# UNITED STATES PATENT AND TRADEMARK OFFICE

APPLICATION NO.	FILING DATE	FIRST NAMED INVENTOR	ATTORNEY DOCKET NO.	CONFIRMATION NO.
10/613,824	07/03/2003	Mustafa Eroz	PD-203009	6911

<b>Office Action Summary</b>	<b>Application No.</b> 10/613,824	<b>Applicant(s)</b> EROZ ET AL.	
	<b>Examiner</b> Mujtaba K. Chaudry	<b>Art Unit</b> 2133

### **DETAILED ACTION**

Figure 15

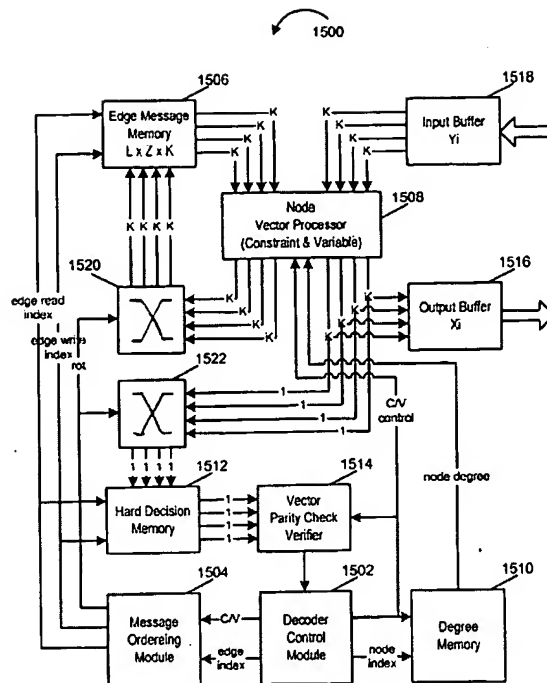
As per claim 2, Richardson teaches (Figure 15) an edge memory which stores the edge values as stated in the present application.

As per claim 3, Richardson teaches (Figure 15) the number of edges attached to a node, i.e., a variable node or constraint node, is referred to as the degree of the node. A regular graph or code is one for which all-variable nodes have the same degree,  $j$  say, and all constraint nodes have the same degree,  $k$  say. In this case we say that the code is a  $(j,k)$  regular code. In contrast to a "regular" code, an irregular code has constraint nodes and/or variable nodes of differing degrees. For example, some variable nodes may be of degree 4, others of degree 3 and still others of degree 2.
